TECHNICAL BULLETIN

[Issue No.] HIME-T-P-0181B

[Title] External appearance changes of the MELSEC-F Series CF card special adapter
FX3U-CF-ADP

[Relevant Models] MELSEC-F series FX3U-CF-ADP

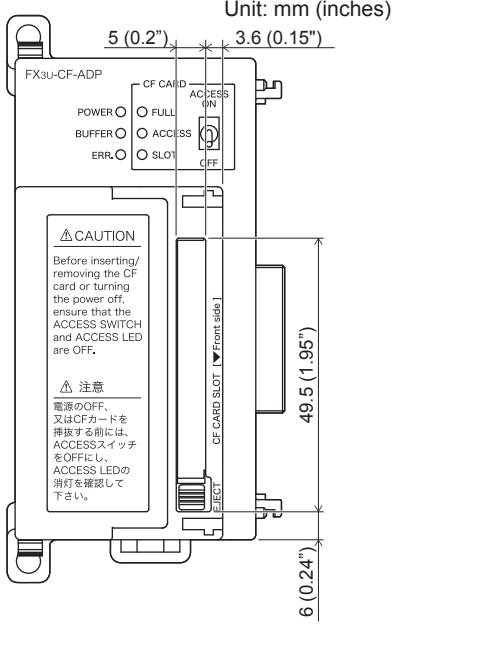
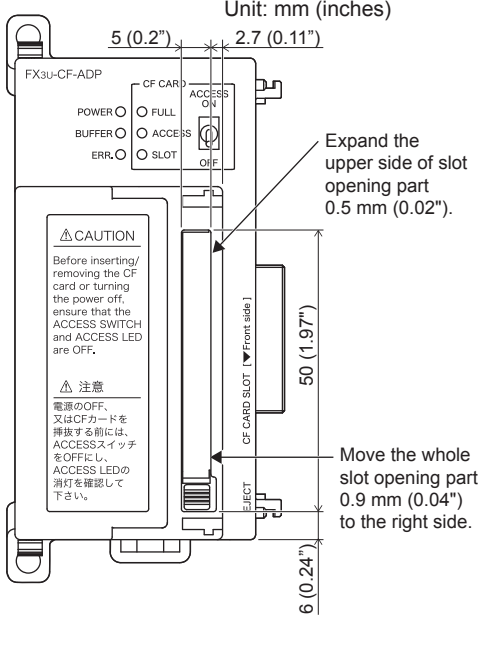
Change points	Before change	After change
<p>Slot opening part position</p>	<p>Unit: mm (inches)</p>  <p>Dimensions: 5 (0.2"), 3.6 (0.15"), 49.5 (1.95"), 6 (0.24")</p> <p>Labels: FX3U-CF-ADP, CF CARD, ACCESS ON, POWER, FULL, BUFFER, ACCESS, ERR., SLOT, OFF, CAUTION, EJECT, CF CARD SLOT (Front side)</p>	<p>Unit: mm (inches)</p>  <p>Dimensions: 5 (0.2"), 2.7 (0.11"), 50 (1.97"), 6 (0.24")</p> <p>Labels: FX3U-CF-ADP, CF CAR, ACCESS ON, POWER, FULL, BUFFER, ACCESS, ERR., SLOT, OFF, CAUTION, EJECT, CF CARD SLOT (Front side)</p> <p>Changes: Expand the upper side of slot opening part 0.5 mm (0.02"). Move the whole slot opening part 0.9 mm (0.04") to the right side.</p>

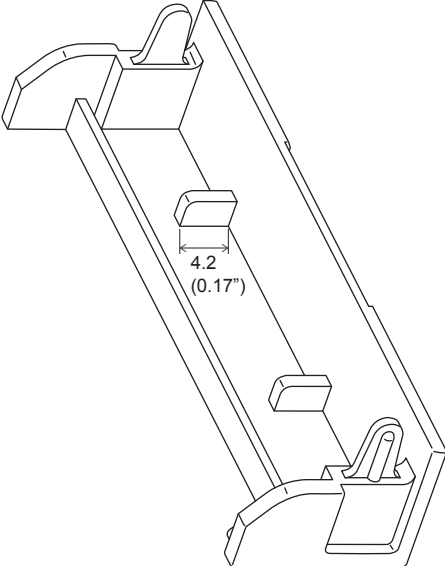
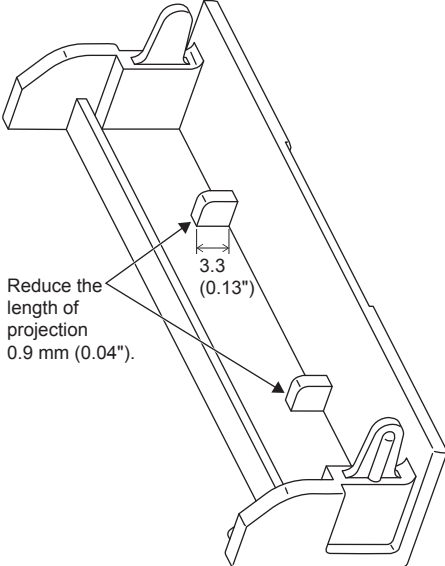
Change points	Before change	After change
Slot display position		 <p data-bbox="986 792 1422 869">The display position of the "EJECT" and "CF CARD SLOT [▼ Front side]" are changed to the right depths.</p>
Slot cover shape	<p data-bbox="742 925 911 949">Unit: mm (inches)</p> 	<p data-bbox="1265 925 1434 949">Unit: mm (inches)</p>  <p data-bbox="991 1227 1118 1317">Reduce the length of projection 0.9 mm (0.04").</p>
